ADDENDUM #2

To: Prospective Bidders
From: Porter Co. Dept. of Development & Storm Water Management
Date: January 21, 2022
Subject: Troon Subdivision – Storm Water Management System Improvements
Construction Services

Troon Subdivision – Storm Water Management System Improvements

PROJECT:	TRON SUBD. -SWM SYSTEM IMPROVEMENTS
LOCATION:	TRON SUBD. -701 TRON DRIVE
SHEET TITLE:	SHEET 3-PLAN

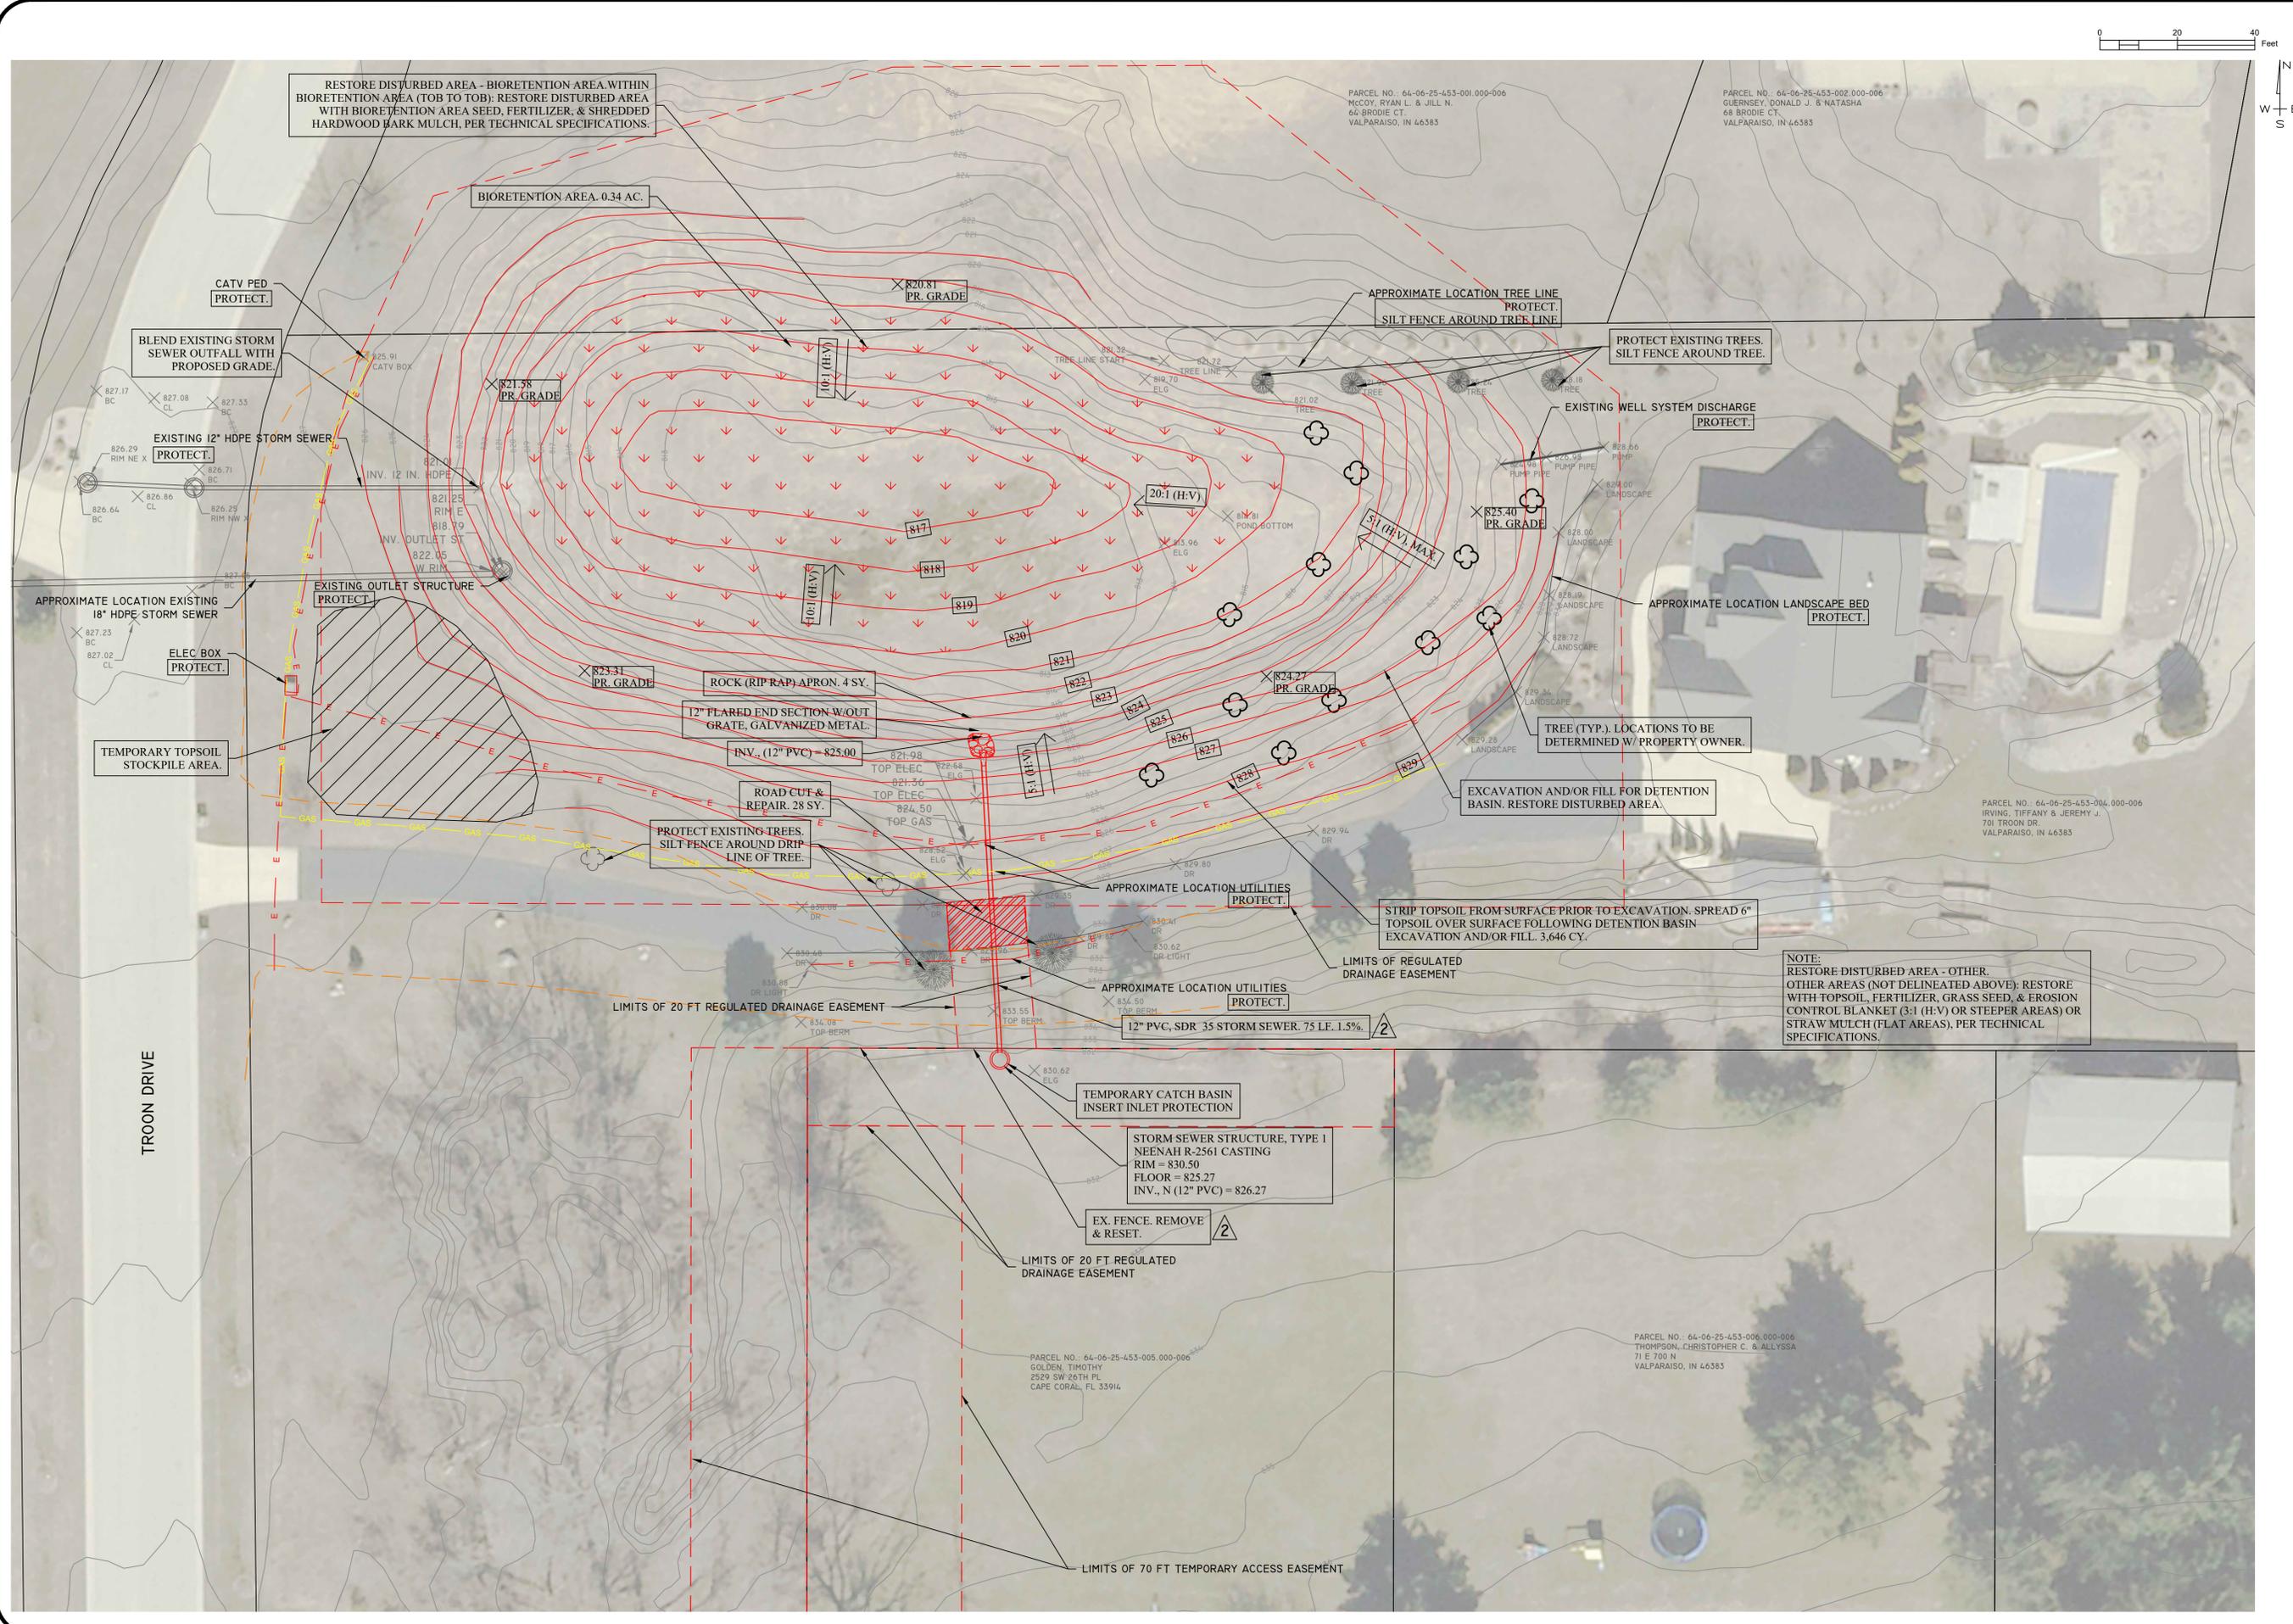
2. 12" PVC, SDR 35 Storm Sewer
The construction plans have been revised to reflect the correct length of "12" PVC, SDR 35 Storm Sewer" needed to successfully complete the work. The correct length is 75 LF, not 85 LF, as previously noted on the construction plans. **To clarify**, deflection testing will only be required by the Department if the required storm sewer televising indicates areas of deflection or other concerns within the storm sewer system.

3. Existing Fence, Remove & Reset
The construction plans have been revised to show the existing fence located on the north property line of the property commonly known as 69 E 700 N. This fence should be removed and reset, as needed, to allow for the performance of the work. Such fence removal and reset shall be considered incidental to the work and the various other items of work involved and will not be measured for payment.

- Q6: The storm sewer pipe length on the plans is 85 LF whereas the Basis of Bid Form is 75 LF. Which is correct?
- A6: The correct pipe length is 75 LF. The construction plans will be revised and such revised plans will be included in Addendum 2 to correct this discrepancy.

Q10: There appears to be a fence located on the north property line of 69 E 700 N. Is this fence to be removed and reset in order to allow for the performance of the work?

A10: This fence should be removed and reset, as needed, to allow for the performance of the work. Such fence removal and reset shall be considered incidental to the work and the various other items of work involved and will not be measured for payment.
